Proposal for amendments to UN Regulation No. 79

(Proposal for a Supplement to both the 03 and the 04 series of amendments to UN Regulation No. 79 (Steering equipment)).

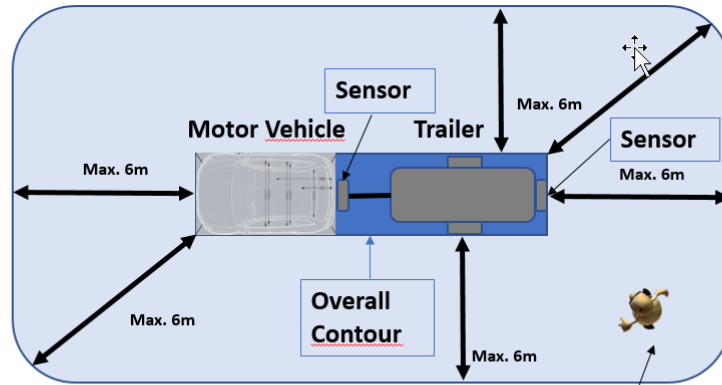
1. The proposal aims to clarify the provisions for ACSF Cat. A "RCP" for vehicle combinations. The current definition for RCP S_{RCPmax} sets a maximum limit of 6m distance to the motor vehicle, which is insufficient in situations where the operation is supervised by the driver located behind the vehicle combination.

2. In reverse parking / manoeuvring-situations this condition offers safety advantages, as the driver can see better what is behind the trailer.
3. All paragraphs providing requirements for a Remote Controlled Parking System remain unchanged and applicable to the vehicle combination.

6. Below is depicted a simplified illustration of the situation for the vehicle combination and the driver.

What means "Specified maximum RCP operating range (S_{RCPmax})" in this case ?

- “2.4.8. *"Remote Controlled Parking (RCP)"* means an ACSF of category A, actuated by the driver, providing parking or low speed manoeuvring. The actuation is made in close proximity to the vehicle **or the vehicle combination**.
- 2.4.9. *"Specified maximum RCP operating range (S_{RCPmax})"* means the maximum distance between the nearest point of the motor vehicle **or of the contour of both vehicles in case of vehicle combination** and the remote control device or alternatively the driver (for systems based on detection of driver position and movement), up to which ACSF is designed to operate.”

S_{RCPmax} = 6m around the countour of the vehicle combination
